***Hazardous Waste Ground-Water
Task Force
Evaluation of
Koppers Tie Plant
Grenada, Mississippi***

JUNE 22, 1987
HAZARDOUS WASTE GROUND WATER TASK EVALUATION
OF KOPPERS CO., INC.
GRENADA, MISSISSIPPI

GROUND WATER MONITORING EVALUATION

KOPPERS TIE PLANT
GRENADA, MISSISSIPPI

Figure 2
RCRA Monitoring Wells Location Map
Koppers Tie Plant
Grenada, Mississippi

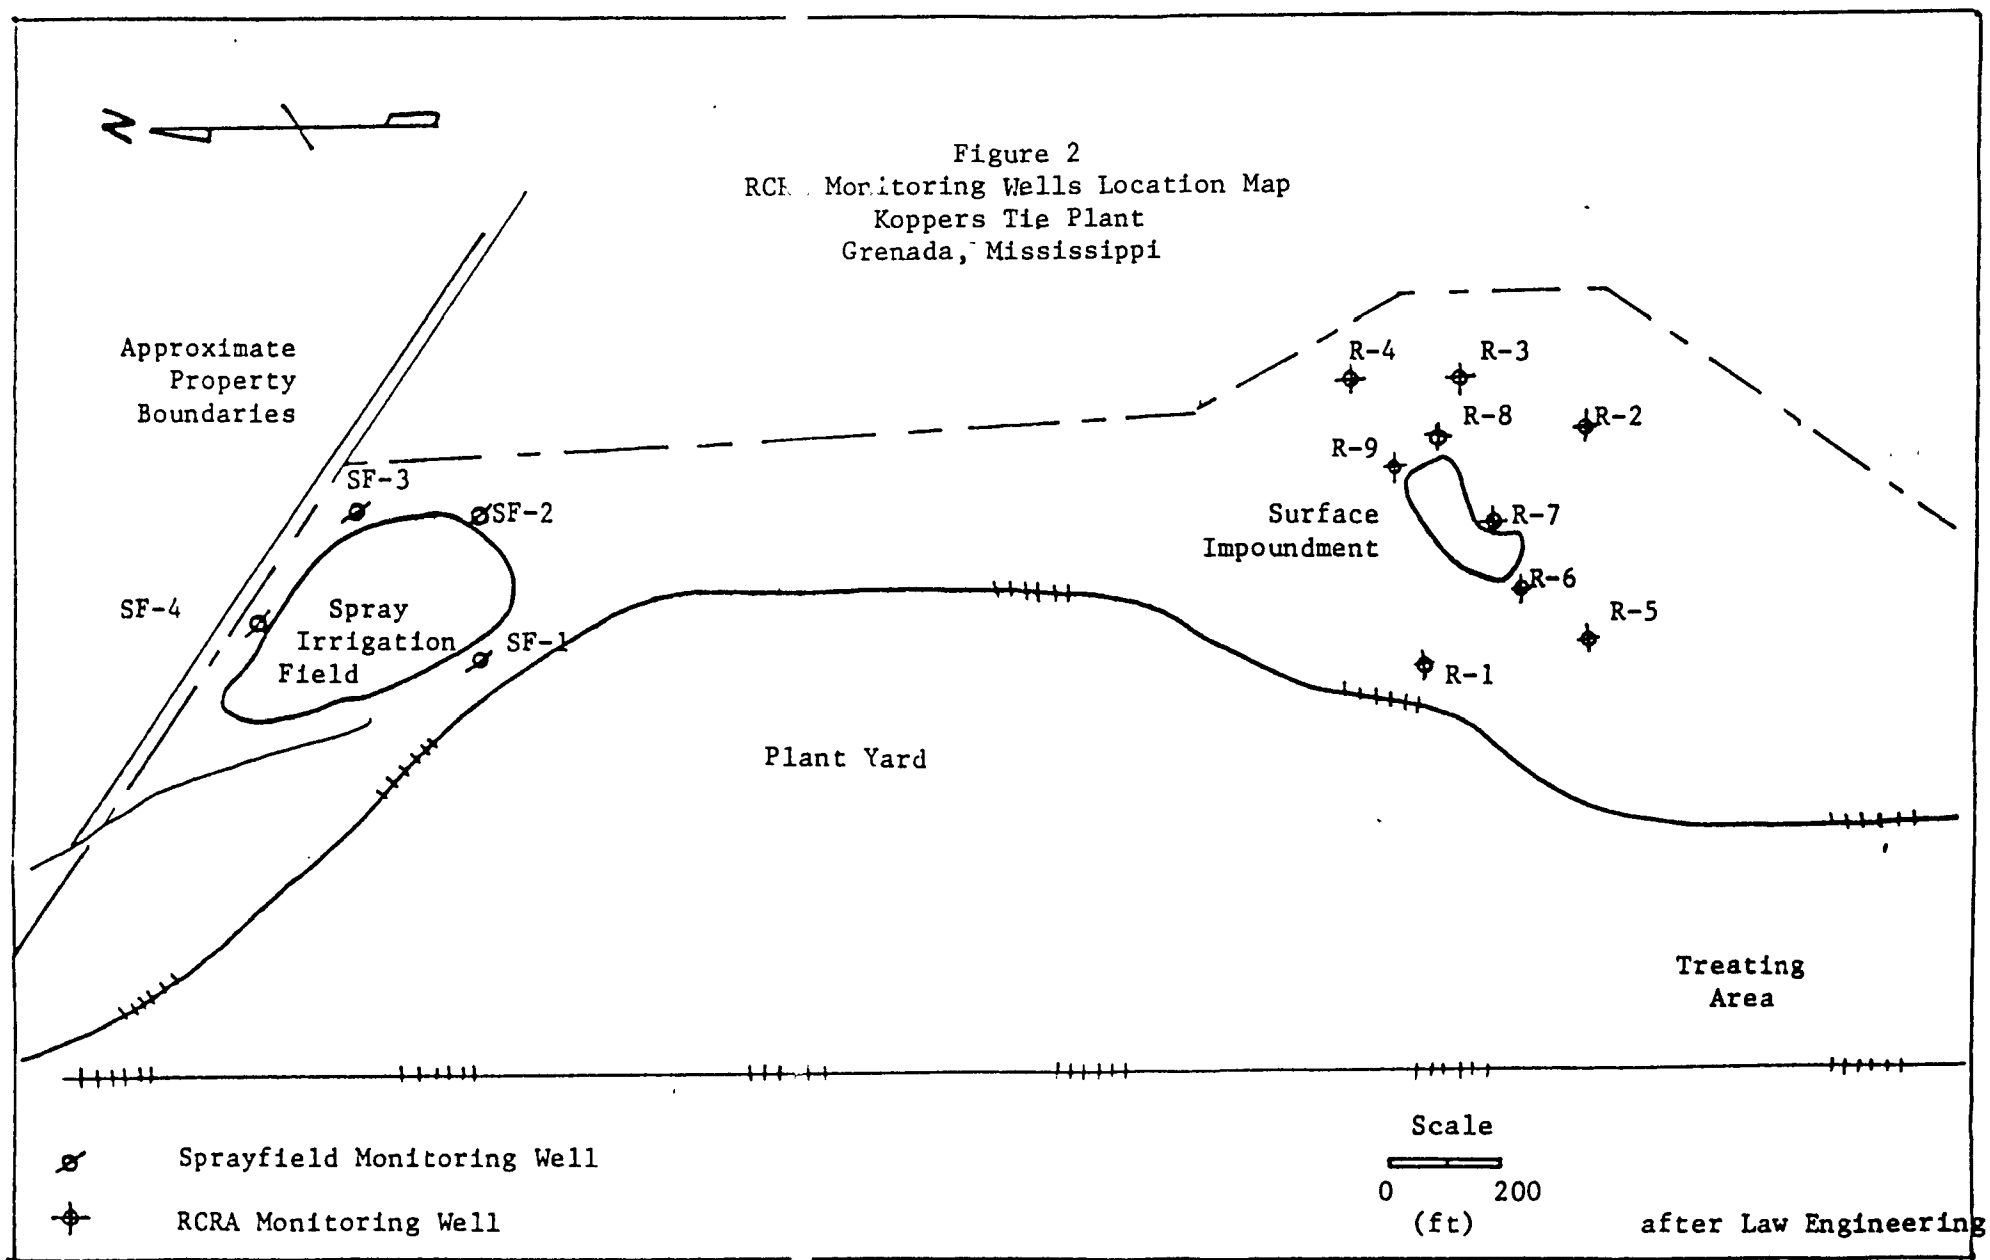
There is not enough information to determine if the monitoring wells are adequately located at the surface impoundment and the sprayfield. It is evident that upgradient well R-5 appears to be affected by the facility and a new well should be required. Also, an unsaturated zone monitoring system is required at the sprayfield. Regulation 40 CFR 265.278 - Unsaturated Zone Monitoring requires owners/operators to implement an unsaturated zone monitoring system which will detect migration of hazardous wastes under the active portion of a land treatment facility, and provide background information on untreated soils. This type of monitoring will show the adequacy of the land treatment process and provide an early detection of contaminant migration.
